# 111 Canfield Gardens: 2021/4585/P - Map

<b>Delegated Report (Members Briefing)</b>		<b>Analysis sheet</b>		<b>Expiry Date:</b>		16/11/2021	
		N/A		<b>Consultation Expiry Date:</b>		19/12/2021	
<b>Officer</b>				<b>Application Number(s)</b>			
Adam Greenhalgh				2021/4585/P			
<b>Application Address</b>				<b>Drawing Numbers</b>			
111 Canfield Gardens London NW6 3DY				Please refer to draft decision notice			
<b>PO 3/4</b>	<b>Area Team Signature</b>	<b>C&amp;UD</b>	<b>Authorised Officer Signature</b>				
<b>Proposal(s)</b>							
<p>Formation of car lift system on paved forecourt to give access to 2 basement car parking spaces. Amended soft garden landscaping to part of frontage, relocated bins and provision of planter, alterations to the existing boundary wall/piers with new mild-steel gates and railings. Works to the ground floor elevation to re-instate the historic elevation of the house.</p>							
<b>Recommendation(s):</b>		<b>Grant Conditional Planning Permission</b>

### **Proposal:**

Existing ground floor and basement plans

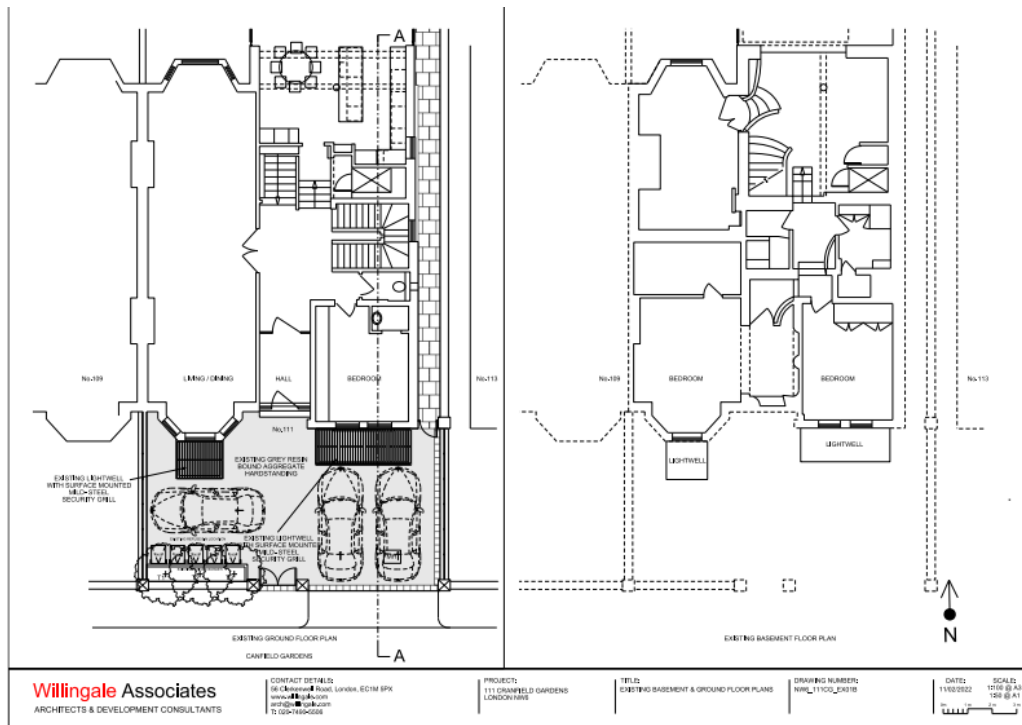
This lightwell, which serves a bedroom in the existing basement under the house, would be replaced with block paving
